Site Accessibility Evaluation

Fire Station 22

Accessibility Evaluation

SUBJECT: Fire Station 22 Self-Evaluation

Finding: 1

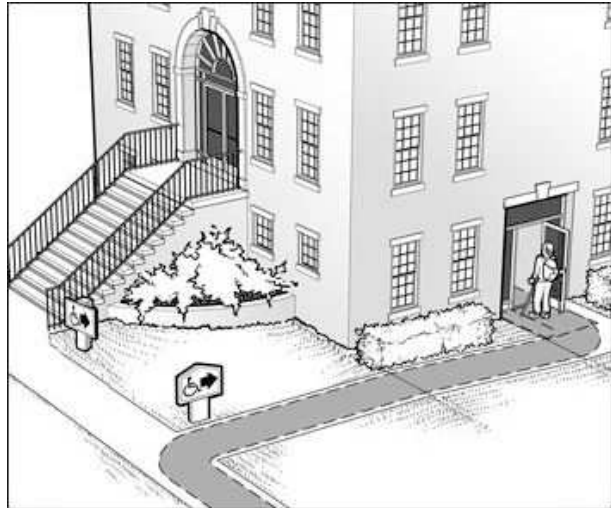
The building entrance is not located on an accessible route.

There is not an accessible route to the front entrance from the parking.

Add concrete panels between the sidewalk and flagpole to create an accessible path to the front entrance.

Finding: 3

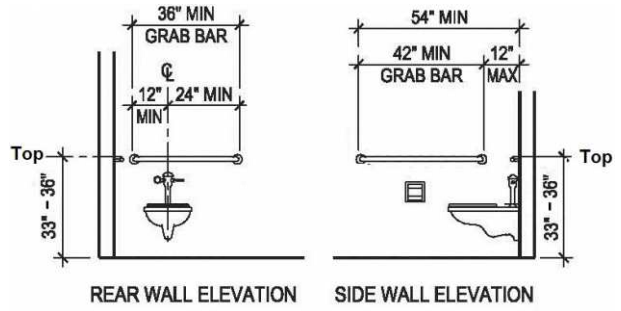
Accessible toilets must have grab bars installed.

The men's restroom does not have grab bars.

Either add grab bars to this restroom, or designate both restrooms as unisex, and the current women's restroom as the accessible restroom.
